**RE: Memorial Regional Hospital OR Expansion**  
**City of Hollywood, Florida**  
File # 24-DP-38  
RAI Response Letter

Per comments from June 17, 2024 regarding the above-referenced project, we offer the following responses:

**Temp Main Entrance  
Traffic Pattern Jun '25 thru Oct '27**

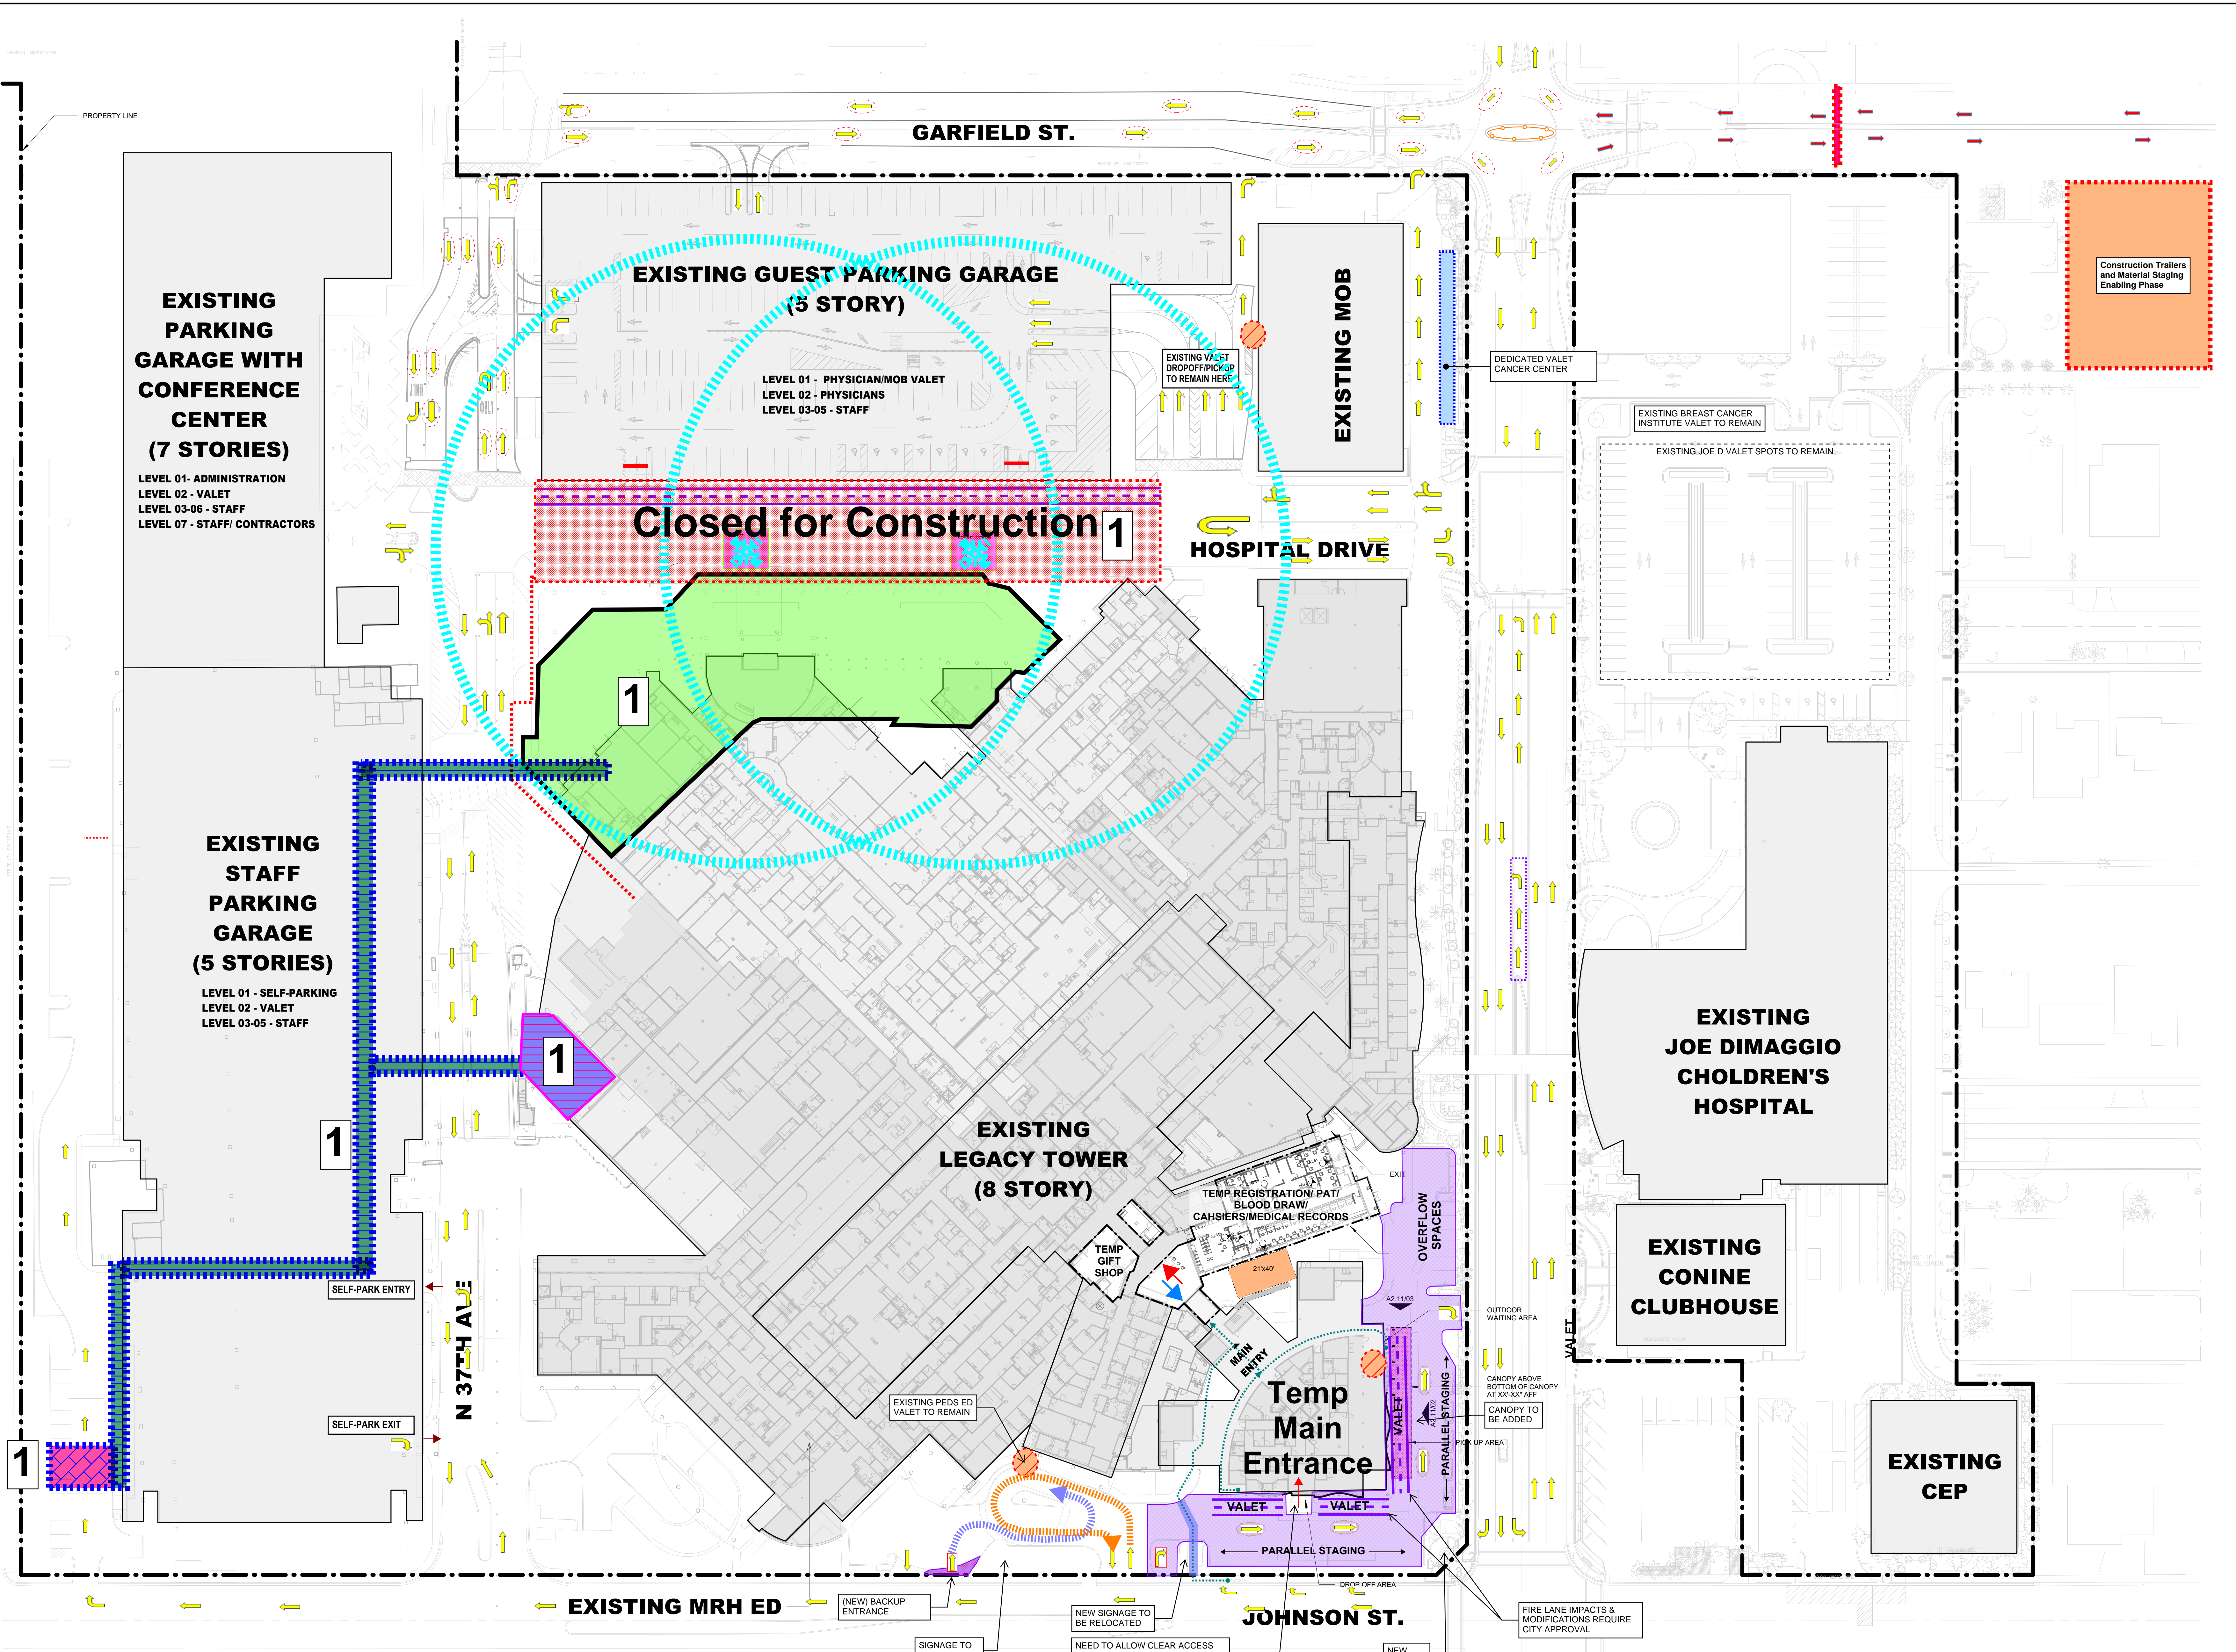
22. Provide separate traffic impact studies to analyze the conditions the proposed temporary relocation of Hospital Main Entrance to 35th Avenue and at project built- out, post hospital expansion. Submit traffic study methodologies for each study for City review and approval prior preparing study.

***Response: Please see attached schedule and construction operational plan.***

**Construction Campus Construction Phase 1**  
**Traffic Pattern Jun '25 thru Oct '27**

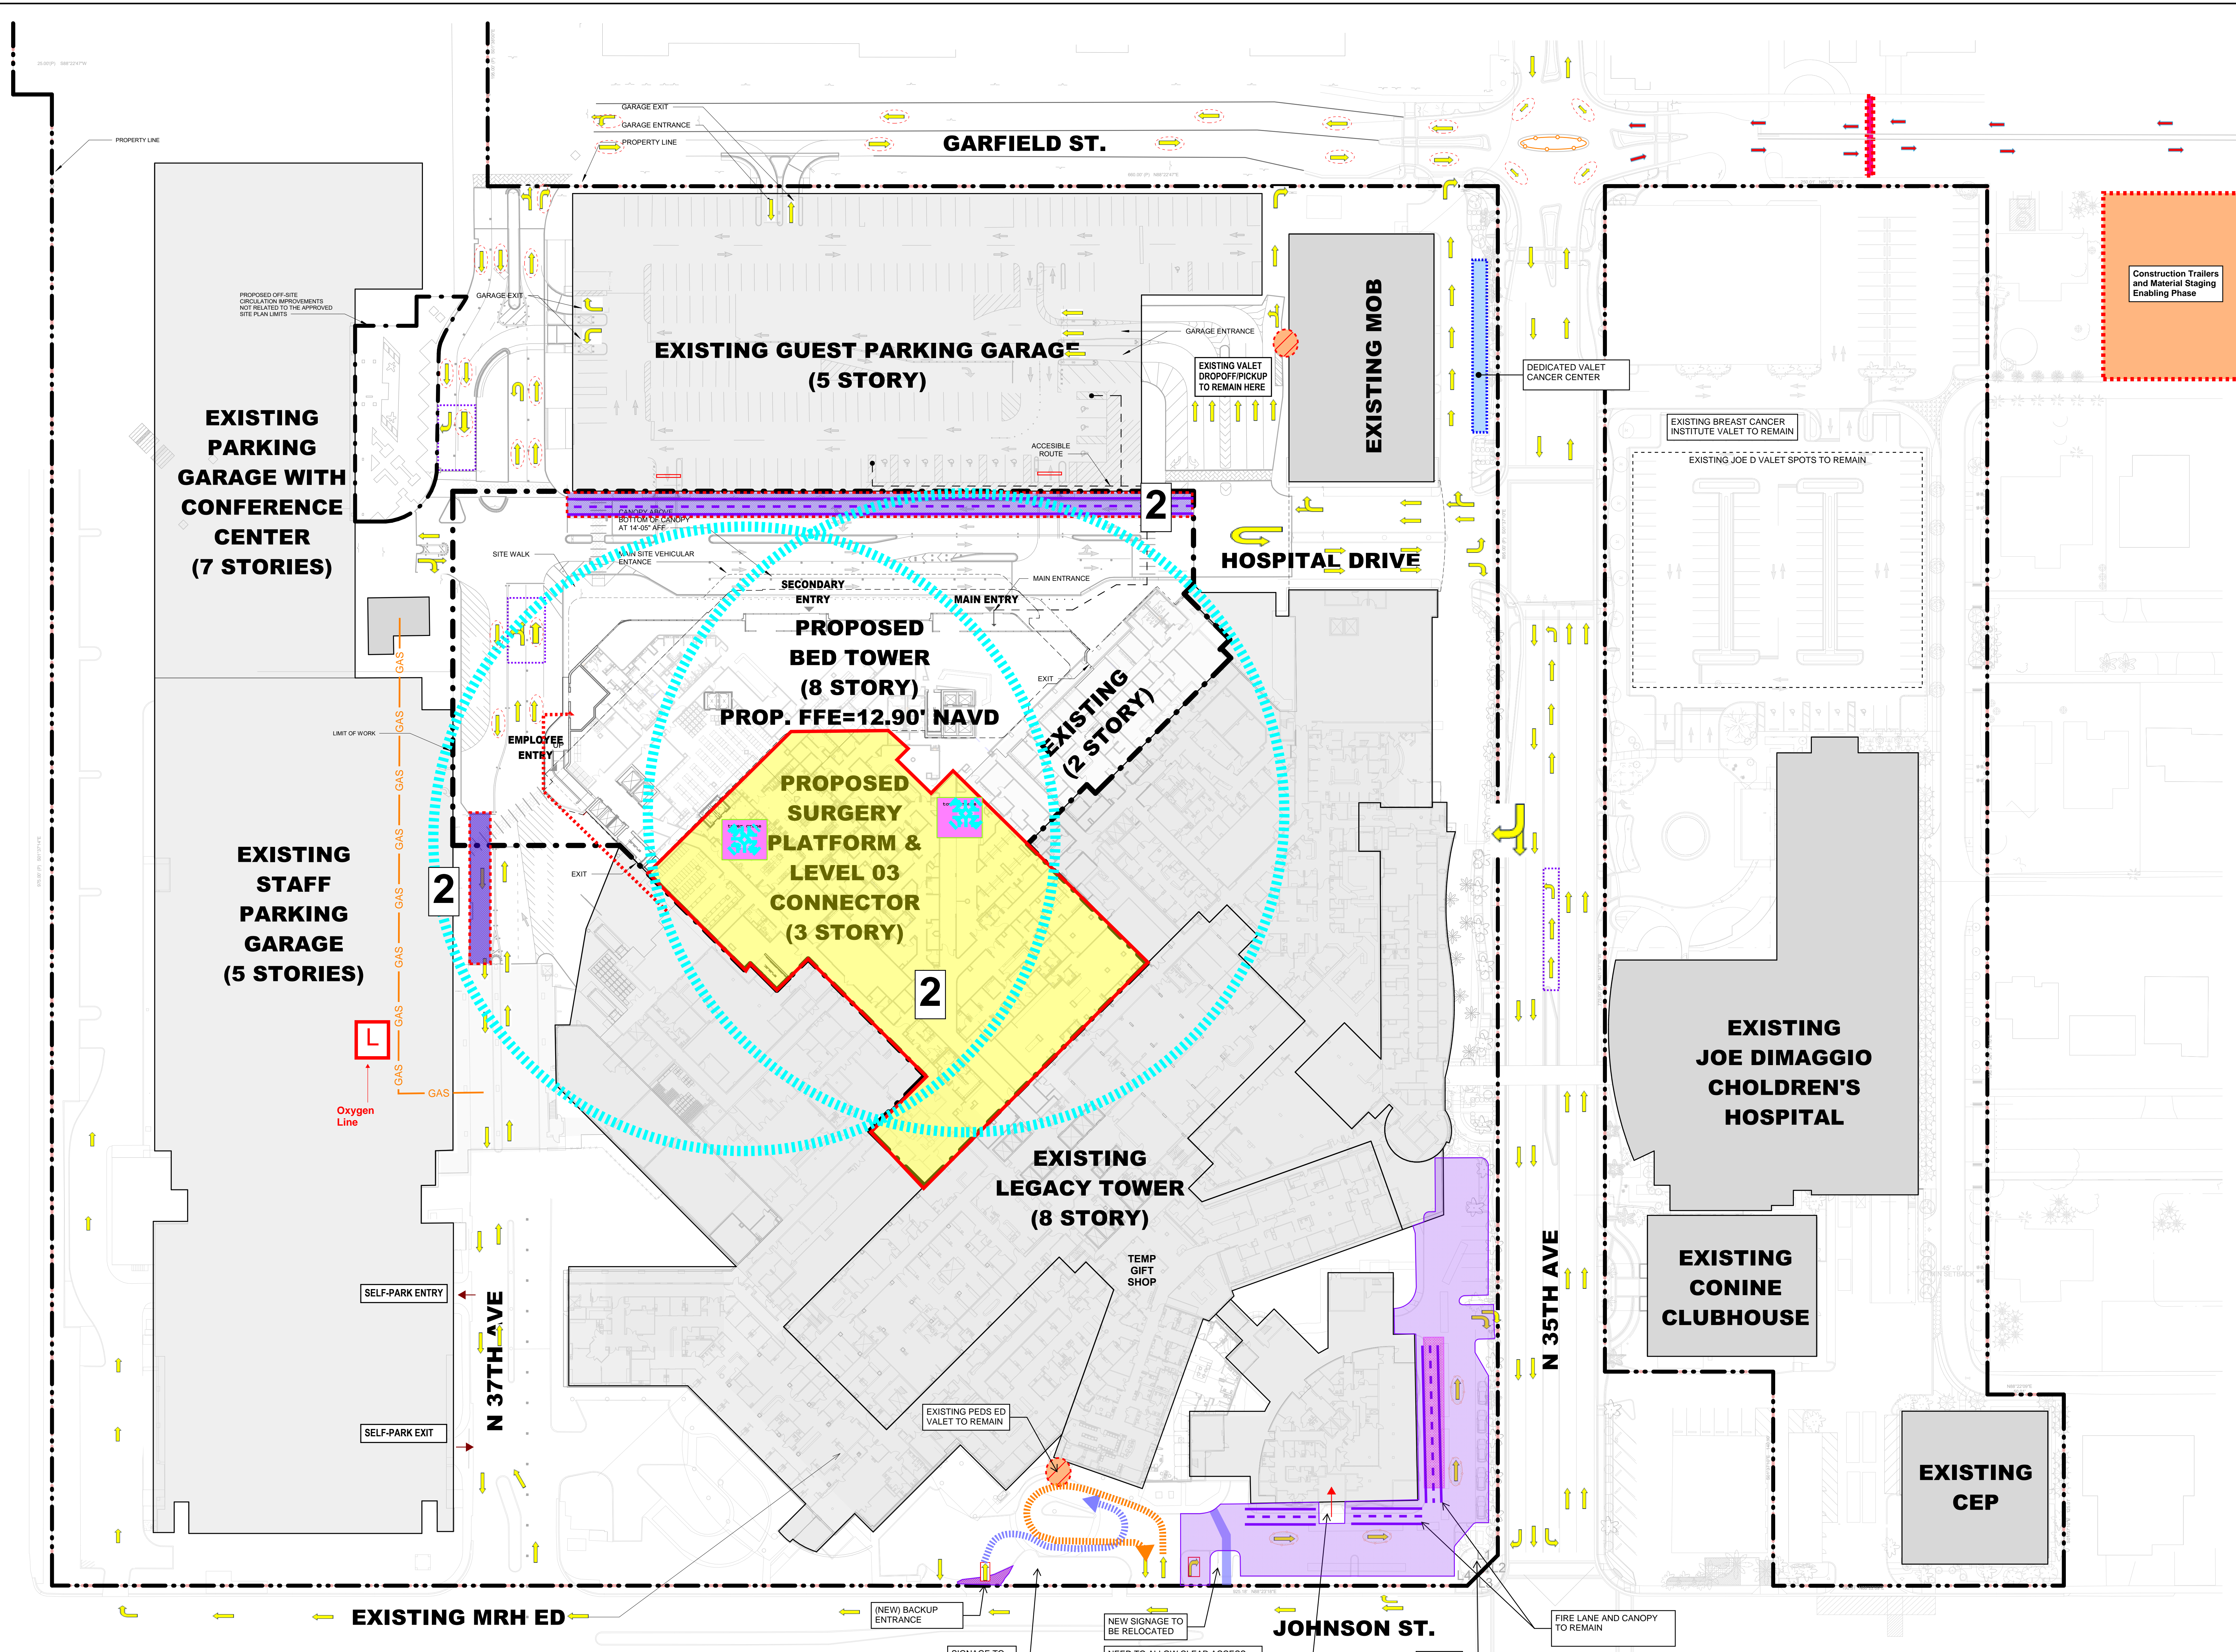
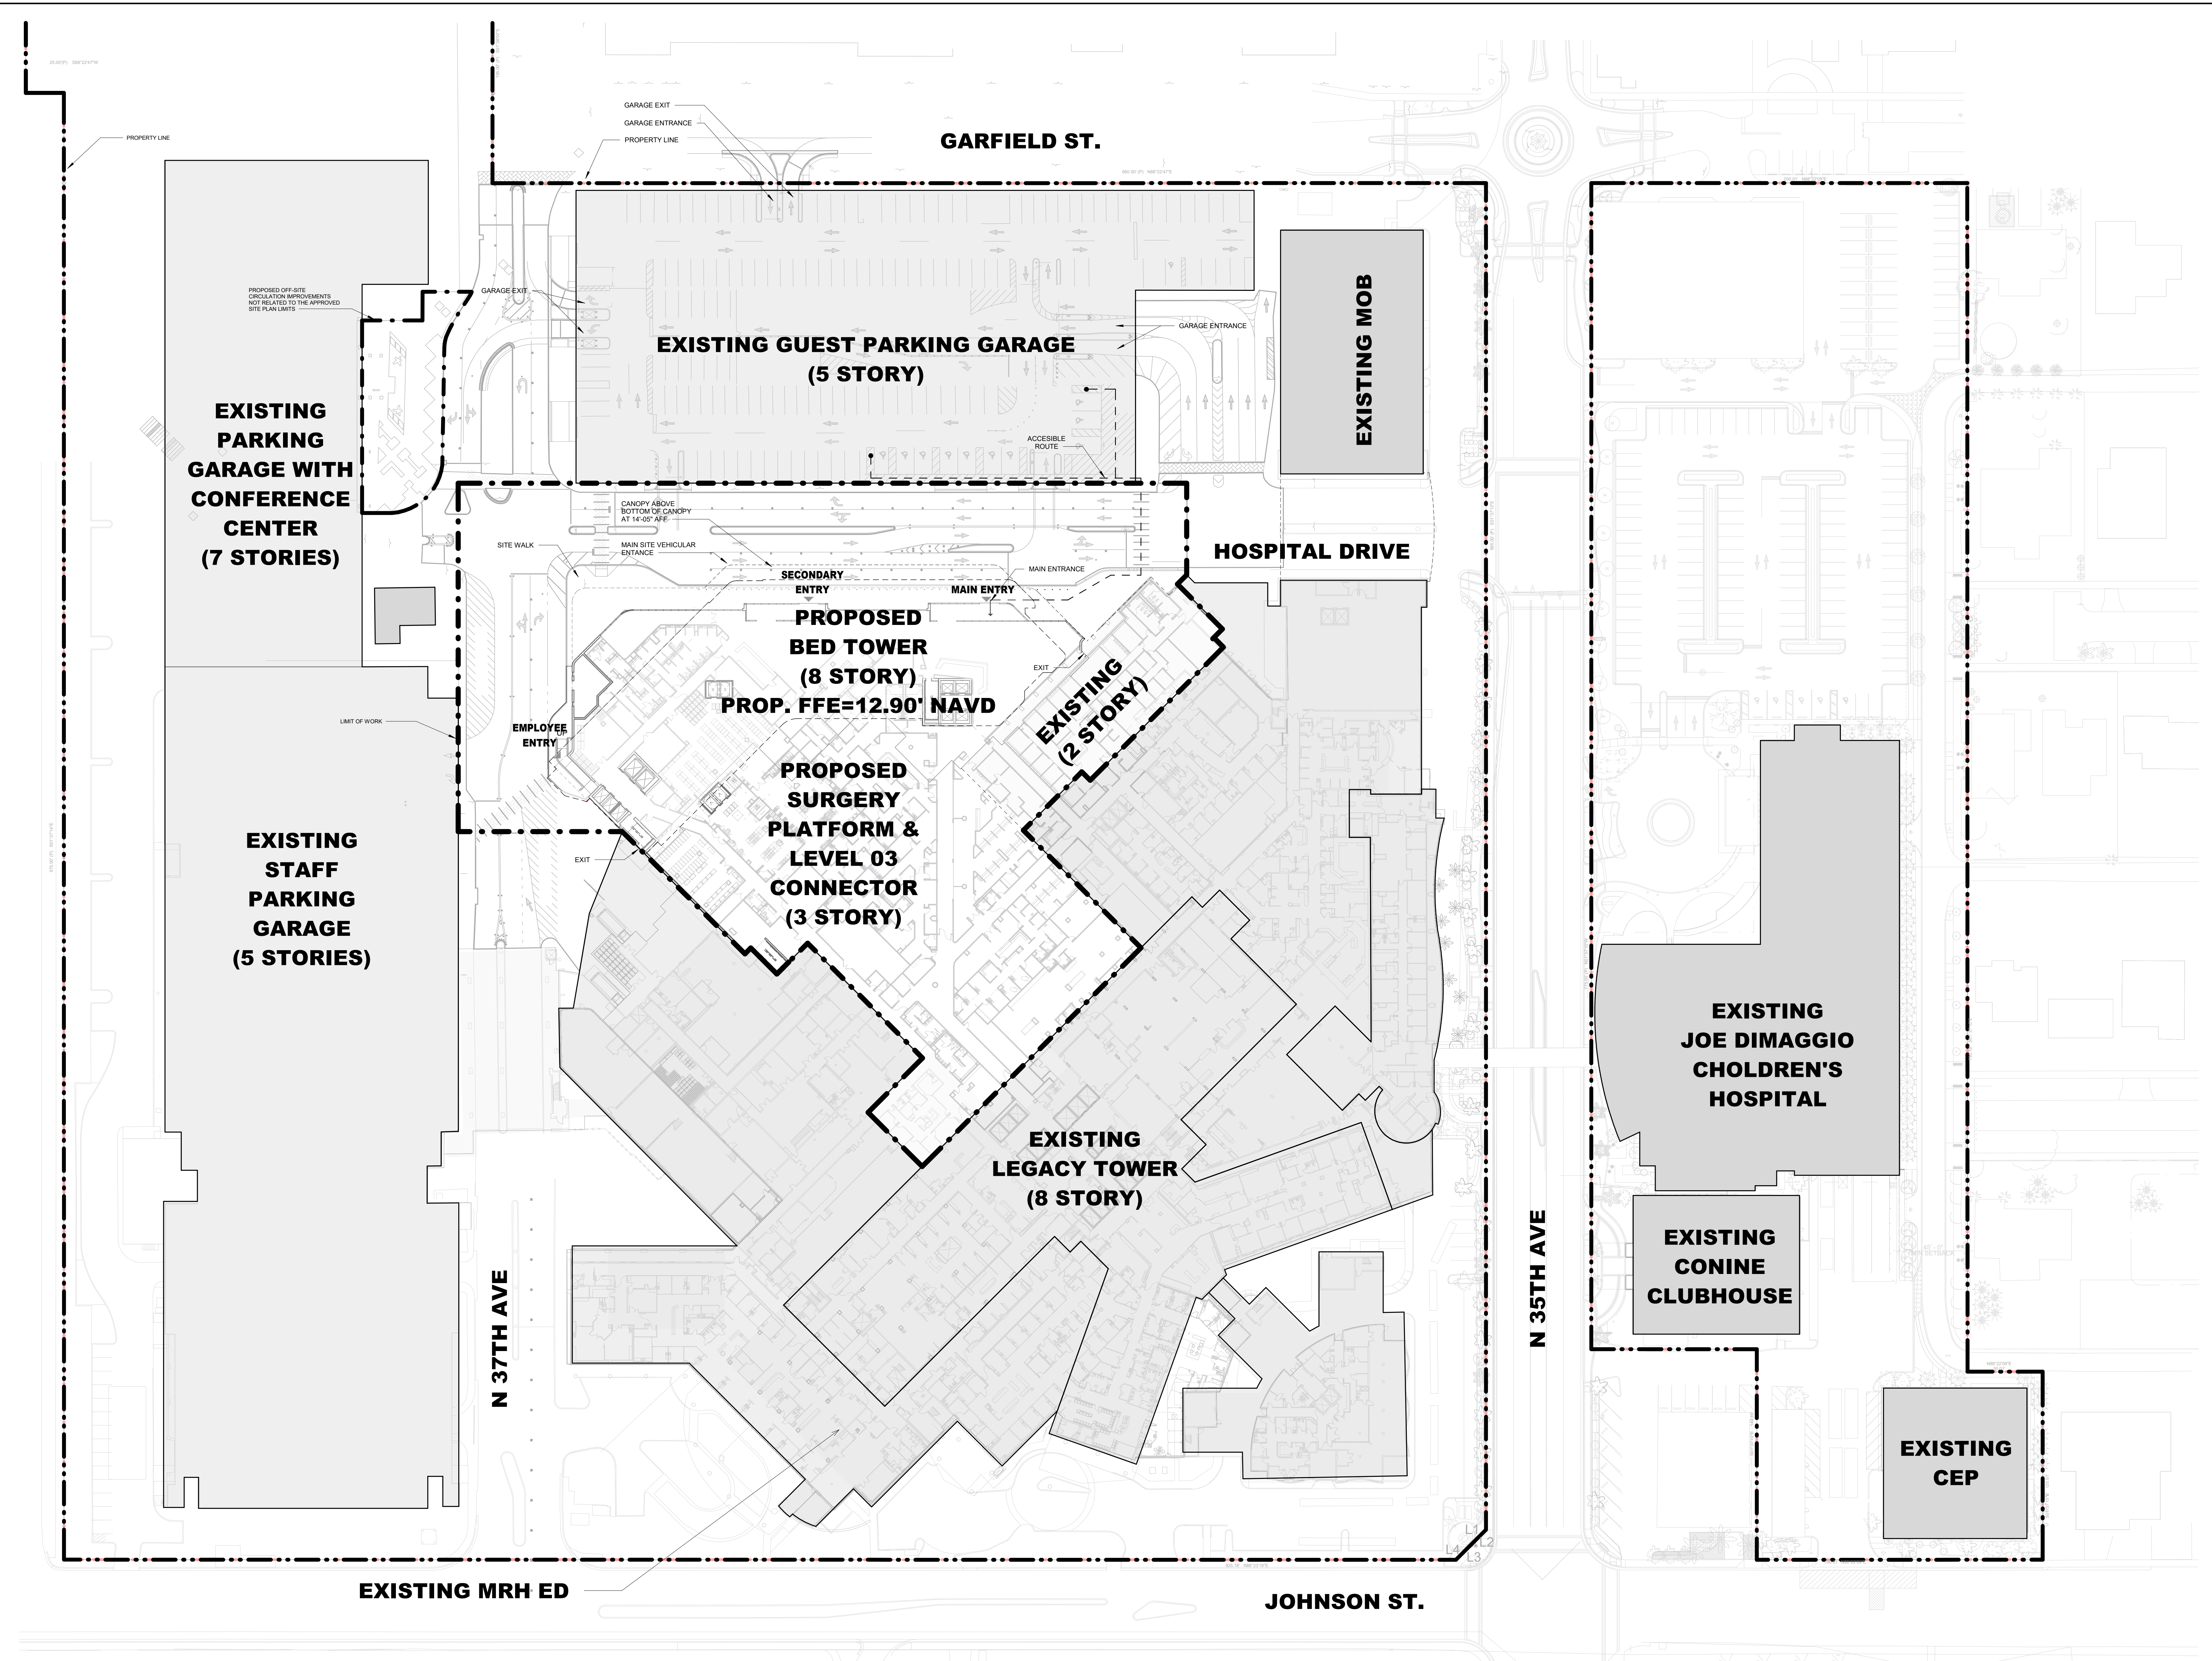
- 23.** Provide anticipated construction schedule with construction phasing/operation plan and staging location/plan. In each phase, please indicate items such as but not limited to estimated duration of each phase, location of construction work zones/areas that will be closed off, construction fence location, vehicular traffic access areas, pedestrian access areas/sidewalks, construction truck routes and location of covered pedestrian walk paths/sidewalks.
